**General Bid Bulletin No. 25**  
31 August 2021

**THE MALOLOS-CLARK RAILWAY PROJECT AND THE NORTH-SOUTH RAILWAY  
PROJECT SOUTH LINE COMMUTER PACKAGE CP NS-01: PROCUREMENT OF  
ELECTRICAL AND MECHANICAL SYSTEMS AND TRACK WORKS (IFB No: 21-040-3)**

**PACKAGE CP NS-01: E&M SYSTEMS AND TRACK WORKS**  
**General Bid Bulletin No. 25**  
**Annex A**

**PACKAGE CP NS-01: E&M SYSTEMS AND TRACK WORKS**  
**General Bid Bulletin No. 25**  
**Annex B**

DATE	MAY 2021
SCALE	AS SHOWN IN A1
SHEET No.	1 OF 1
DRG No.	NSCR-GCR-NS01-ZWE-DWG-DS-000002
DRG S.	REV 02

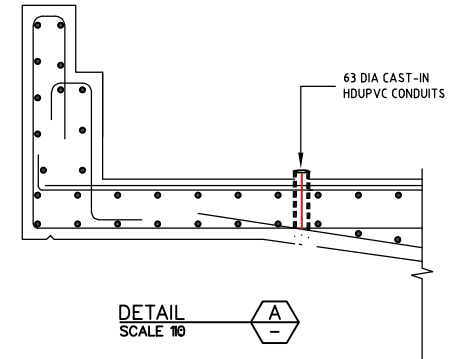
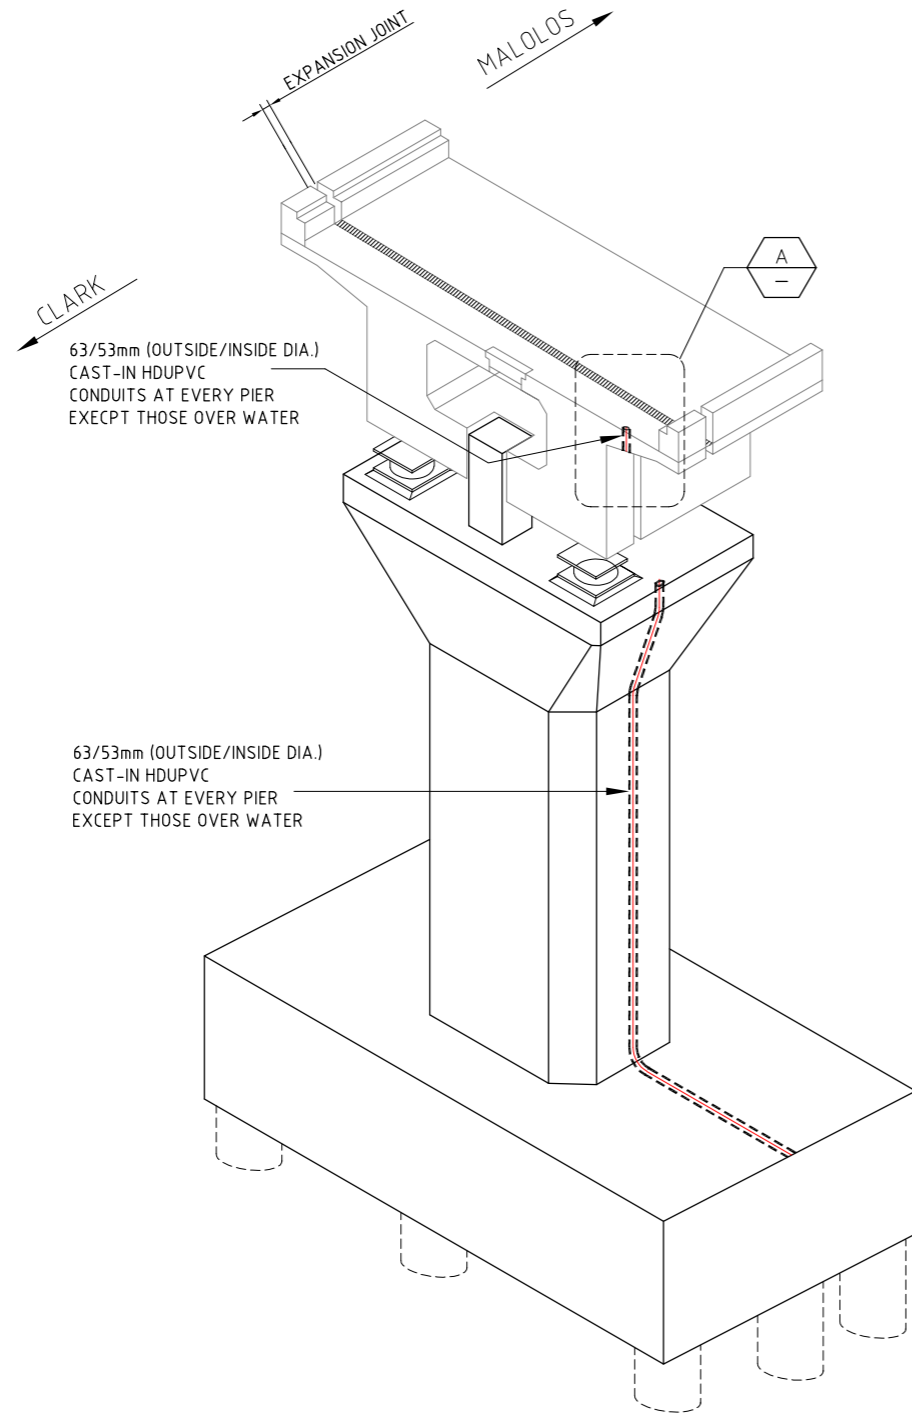
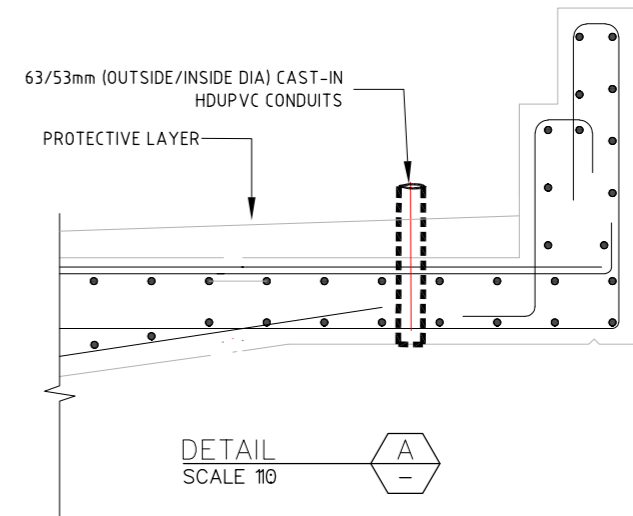
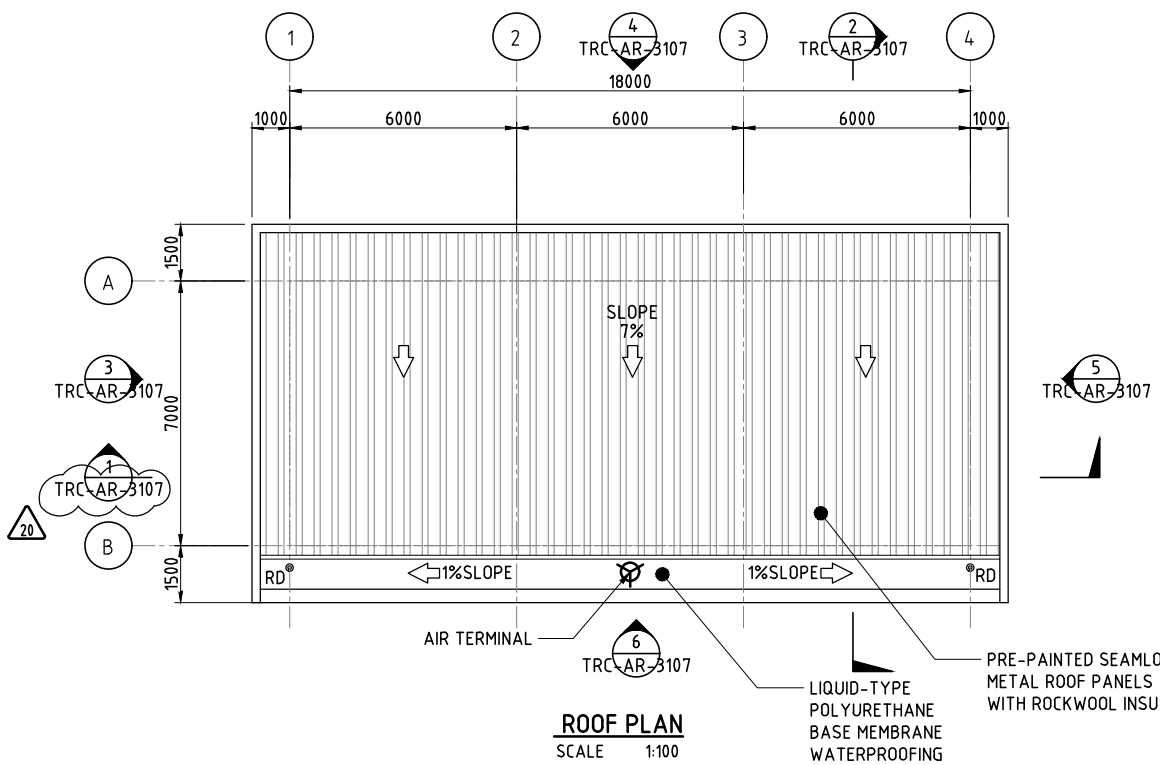
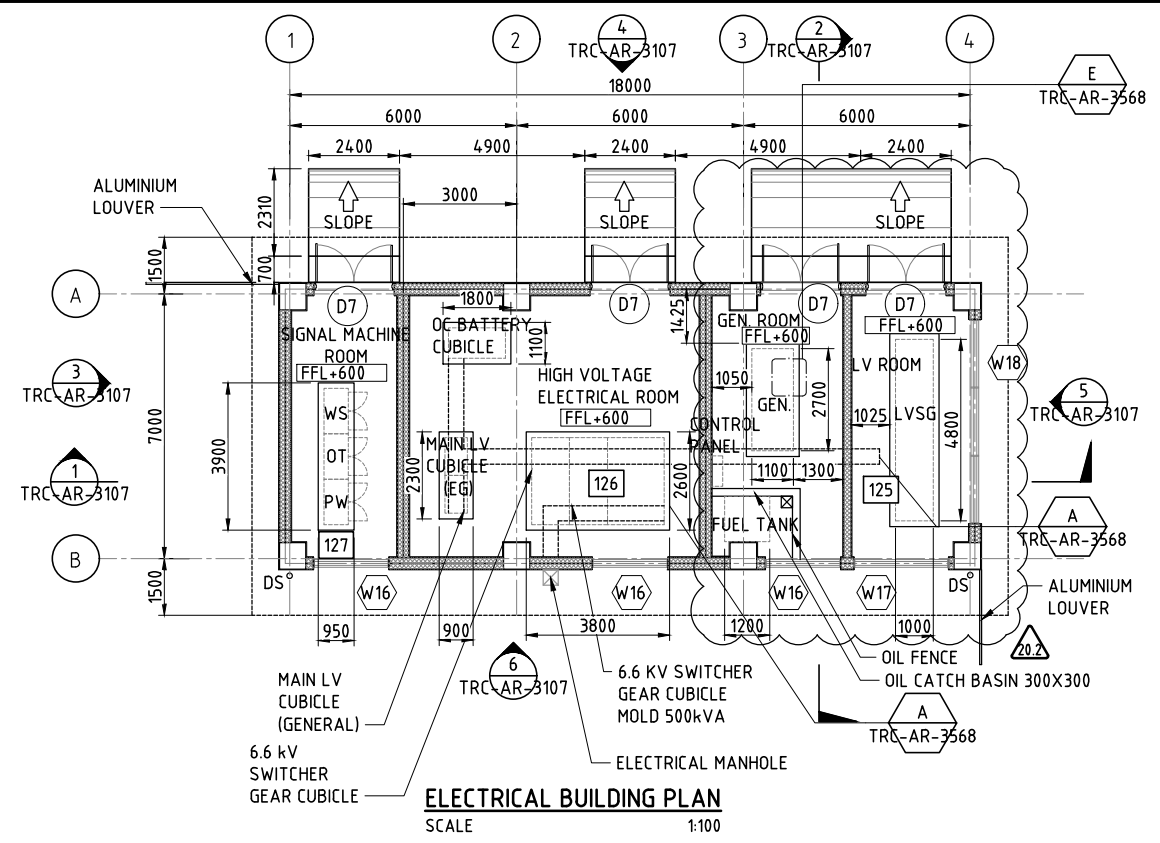
<b>Volume III Part 2 – Employer's Requirements d) Employer's Drawings</b>		
15	Volume III Part 2- Employers Requirement Drawings (a)	Drawing NSCR-GCR-NS01-ZWE-DWG-DS-000002 Rev.01 issued in GBB 16 is change to drawing; "NSCR-GCR-NS01-ZWE-DWG-DS-000002 Rev.02"
16	Part 2 Vol.3 ERD (a) page 246, MCRP-DWG-DEP-PDS-0015	Drawings Added: Training Centre Electrical Building- Equipment and Generator Foundation & Layout MCRP-DWG-TRC-AR-3106 MCRP-DWG-TRC-AR-3107 MCRP-DWG-TRC-ST-4401 MCRP-DWG-TRC-ST-4403 MCRP-DWG-TRC-ST-4411
17	GBB15 Annex B Item no.11 Page 41, MCRP-DWG-PDS-0004	Transformer sizes revised.

DATE	21 JUNE 2019
SCALE	NONE
SHEET No.	6 OF 20
DRG No.	MCRP-DWG-CIA-PDS-0006
DRG S.	-
REV	01

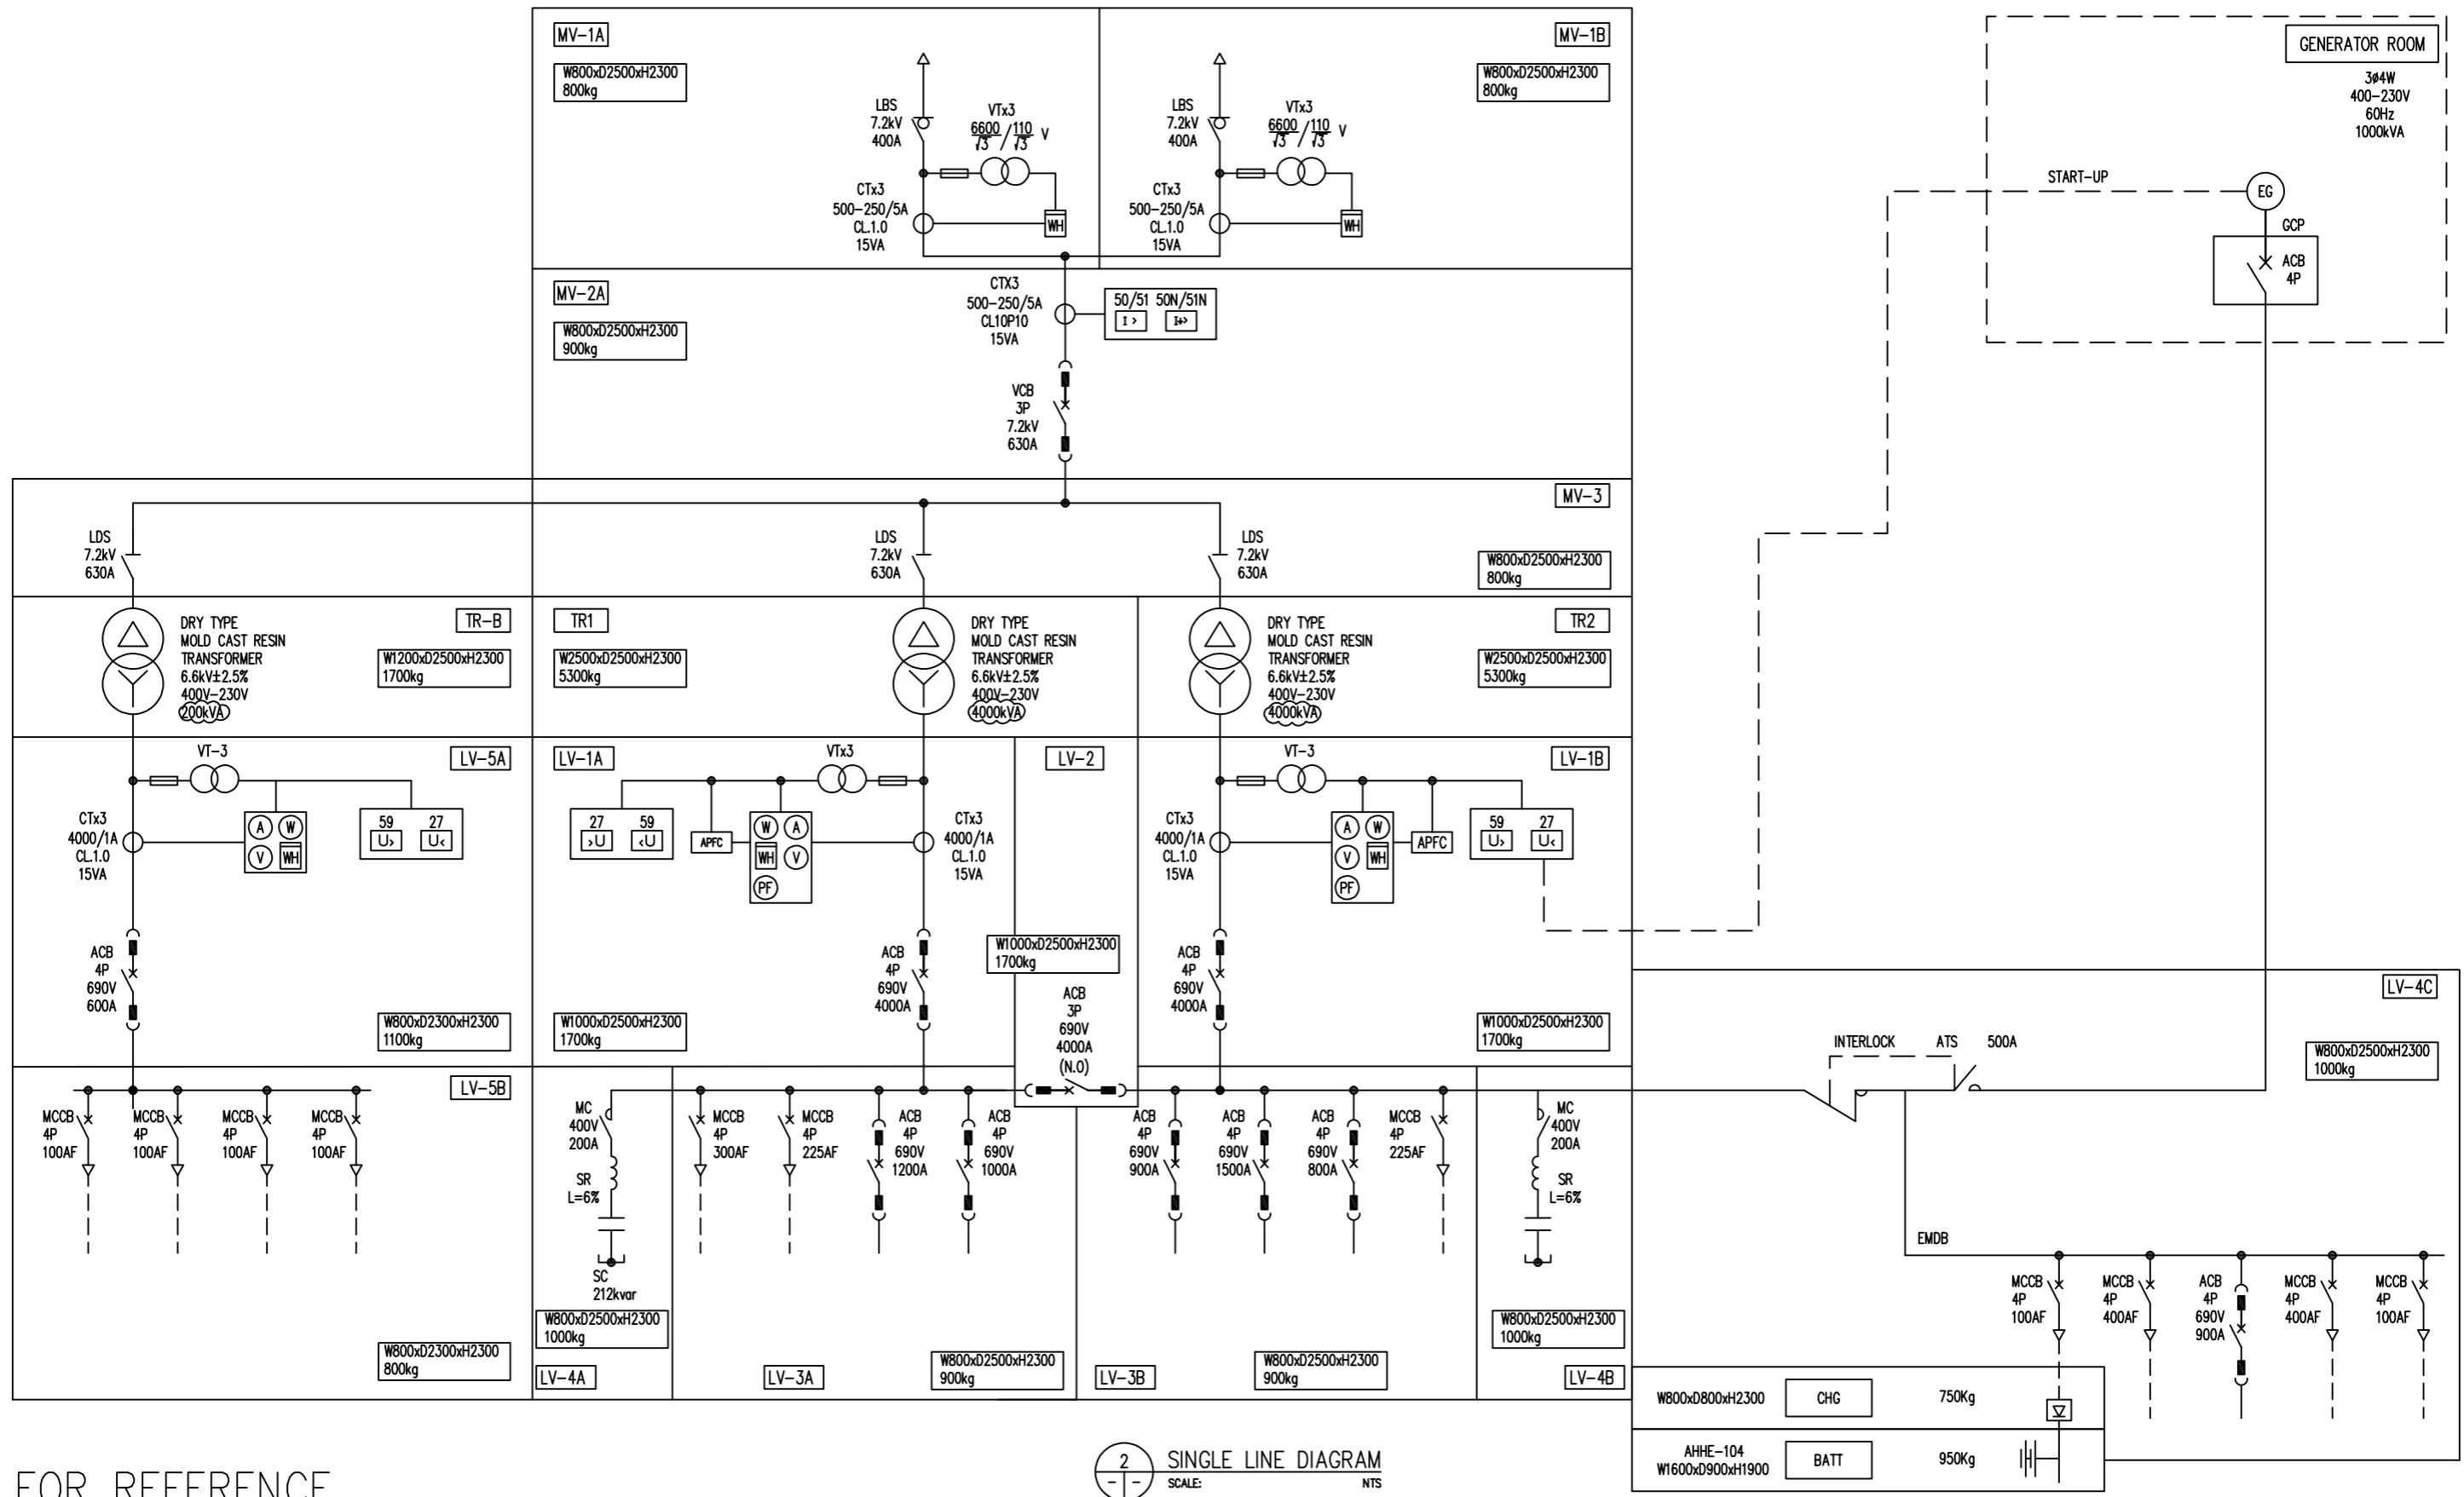
18	Part 2 Vol.3 ERD (a) page 236, MCRP-DWG-CIA-PDS-0005	Transformer sizes revised.
19	Part 2 Vol.3 ERD (a) page 237, MCRP-DWG-CIA-PDS-0006	Transformer sizes revised.
20	Part 2 Vol.3 ERD (a) page 241- MCRP-DWG-DEP-PDS-0010	Transformer sizes revised.
21	Part 2 Vol.3 ERD (a) page 242, MCRP-DWG-DEP-PDS-0011	Transformer sizes revised.
22	Part 2 Vol.3 ERD (a) page 243, MCRP-DWG-DEP-PDS-0012	Transformer sizes revised.
23	Part 2 Vol.3 ERD (a) page 244, MCRP-DWG-DEP-PDS-0013	Generator room layout revised and transformer sizes updated.
24	Part 2 Vol.3 ERD (a) page 245, MCRP-DWG-DEP-PDS-0014	Transformer size updated
25	Part 2 Vol.3 ERD (a) page 246, MCRP-DWG-DEP-PDS-0015	Transformer size updated

VERSIONS	DATE	DESCRIPTION
00	02 MAR 2021	ISSUED FOR REFERENCE
01	25 AUG 2021	TRANSFORMER SIZES REVISED
